## **DIGBY WIND POWER PROJECT ADDENDUM**

Addendum to Environmental  
Assessment Registration Document

Report Prepared for:  
SkyPower Corp.  
250 Yonge Street  
Toronto, ON M5B 2L7

July 3, 2009

**Figure 1**  
DIGBY WIND POWER PROJECT  
**Site Plan**  
(REVISED LAYOUT)

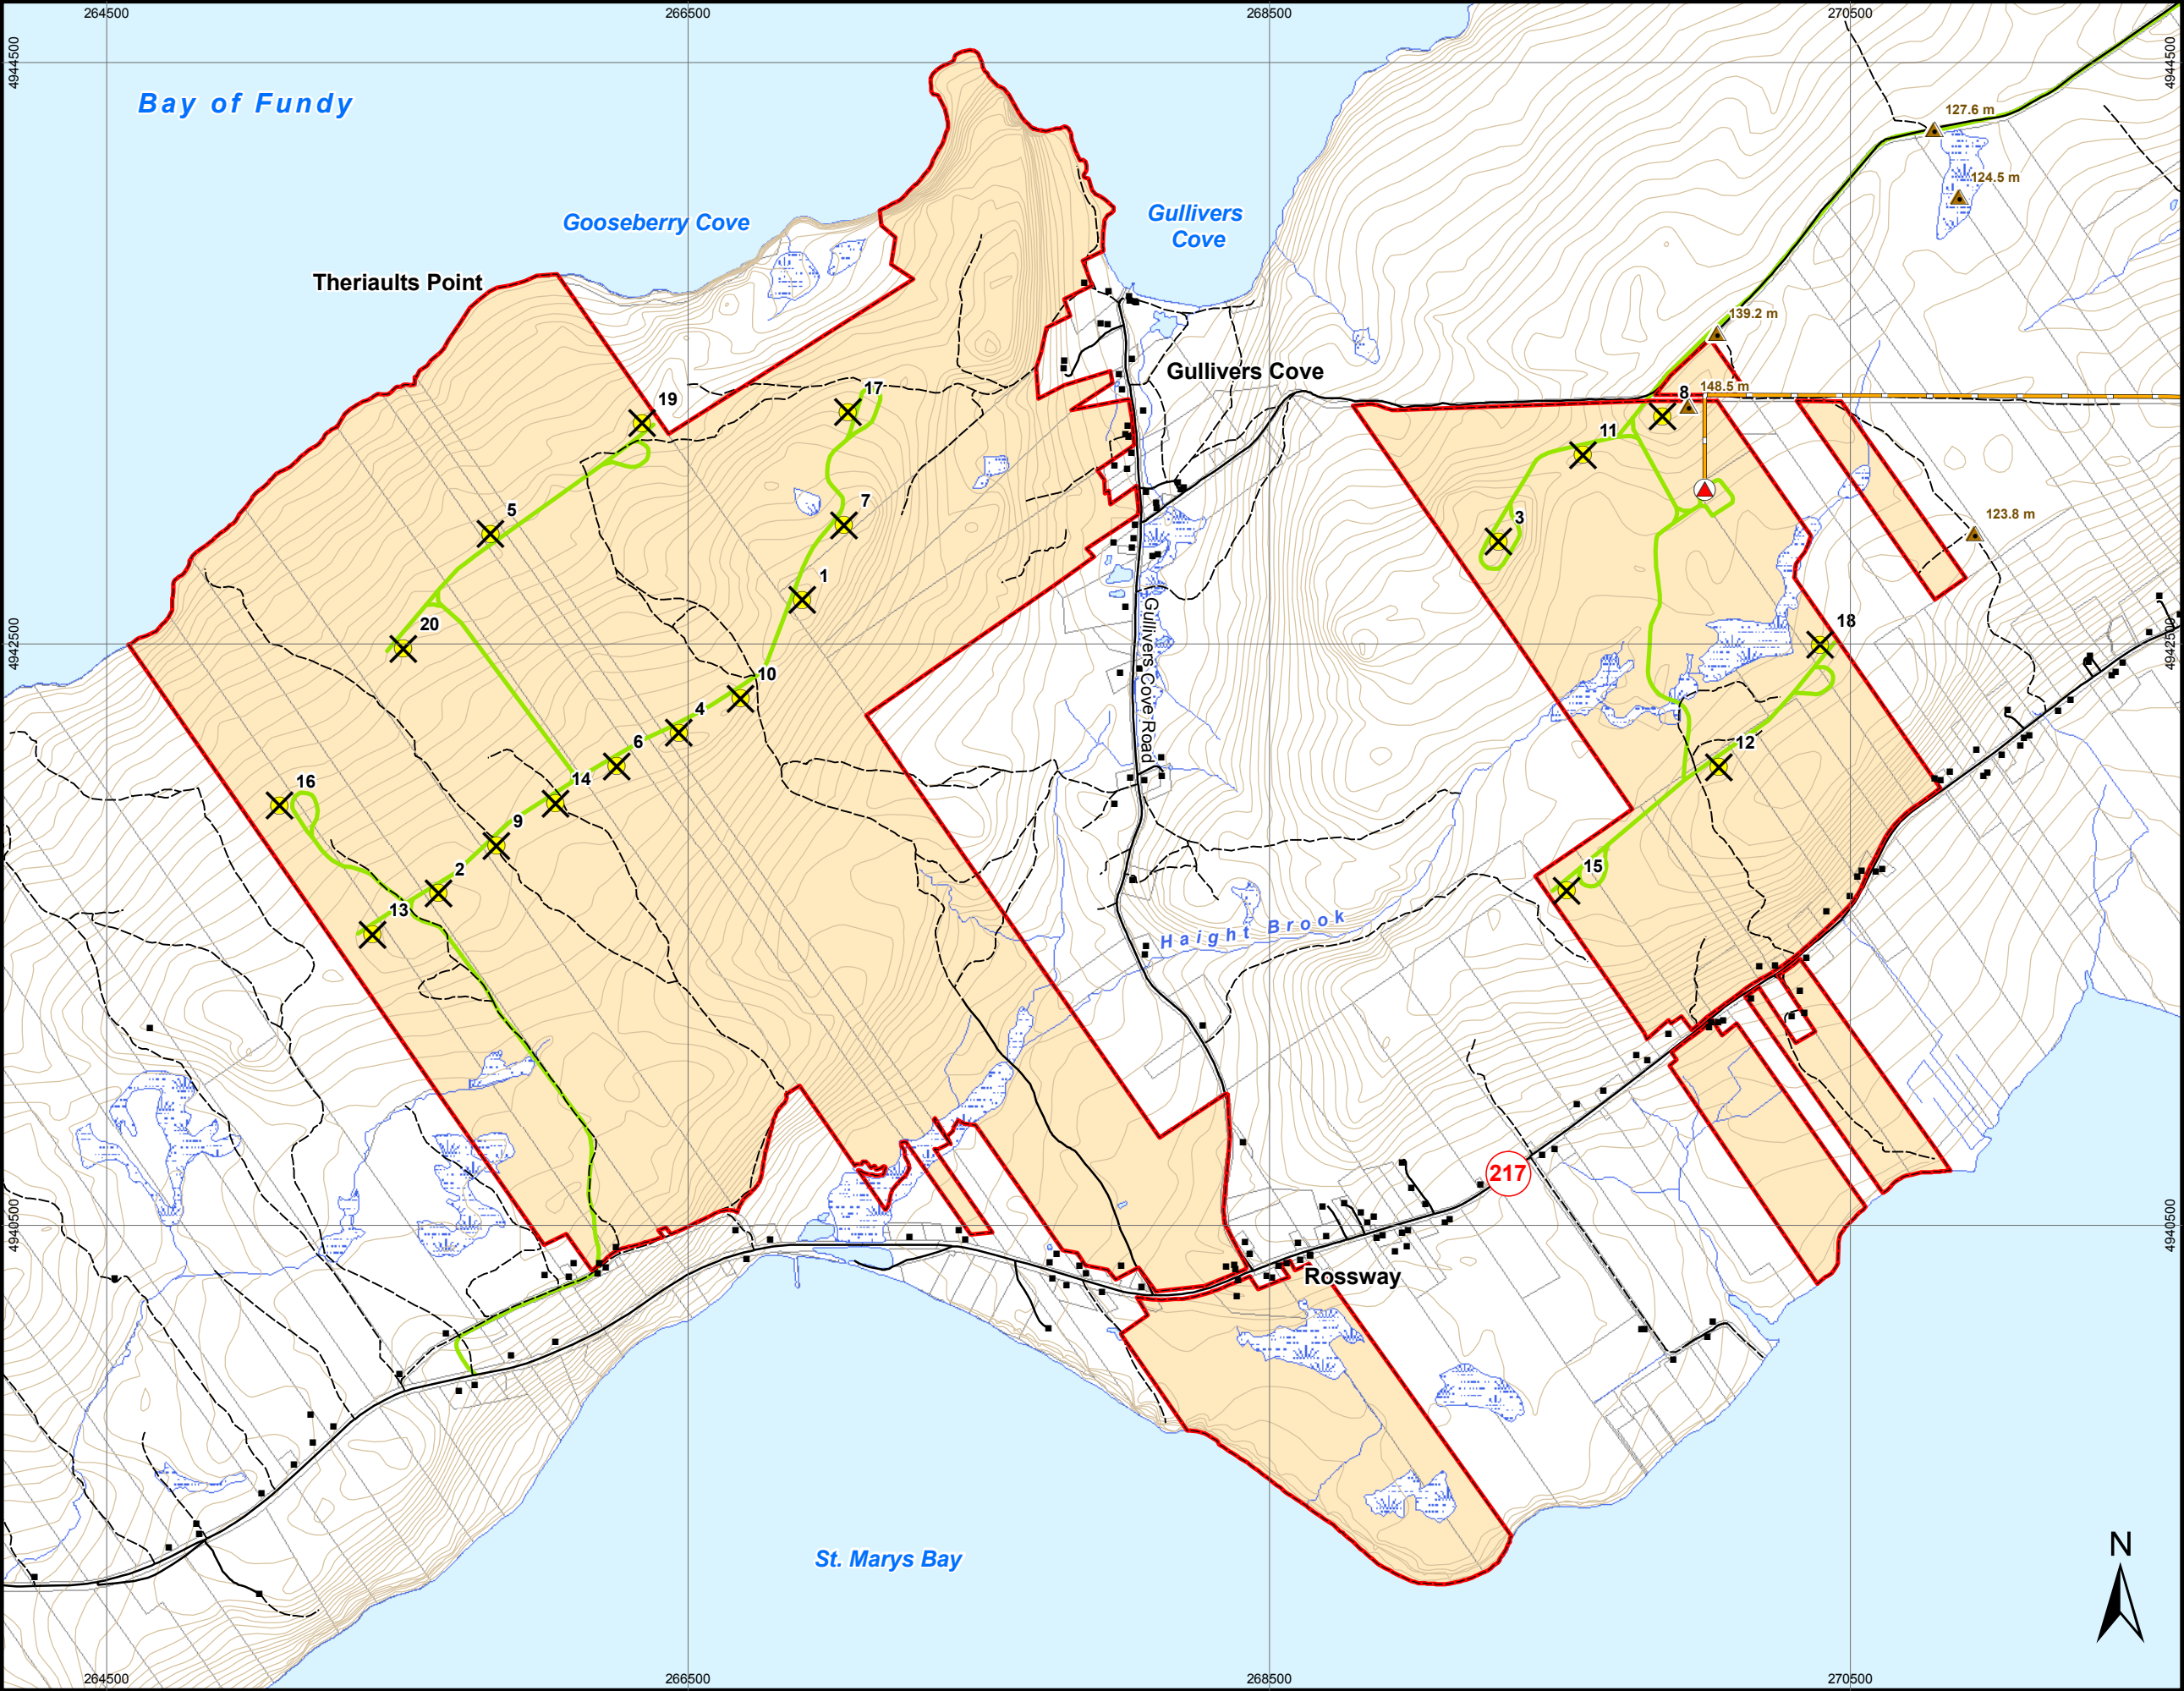
*“During the environmental assessment review it was determined that additional information is required concerning turbine placement and their impact on landscape connectivity and species movement. This information must be developed in consultation with Nova Scotia Department of Natural Resources. Additional information may also be required with respect to potential adverse environmental effects of the Digby Wind Power Project in the event turbines are relocated to accommodate species movement.”*

The Proponent has revised the layout for the Project based on various considerations including stakeholder feedback, from both the public and regulators, and construction feasibility issues identified during detailed planning and design. Figure 1 in Appendix A displays the revised Project layout.

As shown in Figure 1, the revised Project layout minimizes the Project footprint by consolidating turbines in roughly two parallel lines along the mountain ridge on the western parcel of Project lands. This configuration is located more than 300 m from the Bay of Fundy coast resulting in avoidance of cliff habitat previously identified by NSDNR as a sensitive habitat to be avoided and also maintains approximately 50 percent of the peninsula width to the south side of the turbine alignment. This alignment option has turbines placed predominantly within previously disturbed (e.g., clear cut) areas and minimizes effects on wetland complexes and residences located to the south.

In the eastern parcel, Project infrastructure was sited, to the extent possible given other constraints (refer to Section 2), to avoid sensitive environmental features such as wetlands and watercourses. The turbines in the eastern parcel are aligned as two parallel lines, approximately 700 m apart, running in a northeast/southwest direction, to avoid a large wetland complex associated with Haight Brook which could potentially serve as key wildlife habitat and corridor for wildlife movement through the area.
